Current REX

14-5400-1061

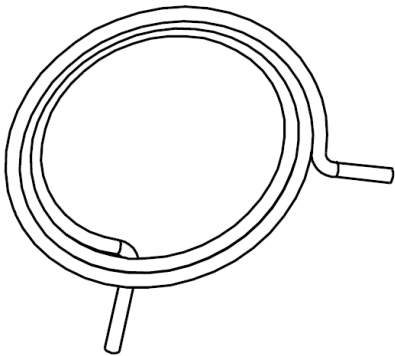
2009 - June 2013

Several revisions, some with cover, some without.

Stop plate had several revisions

Note one leg crosses over the coil

14-5401-1077

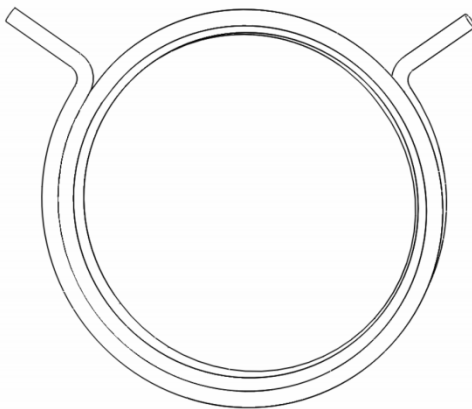
July 2013 - Ongoing

3.75 coils

Engineering made some design changes to the rose support assembly and the return spring that went into production in July of 2013. This spring does not work on locks made before this date.
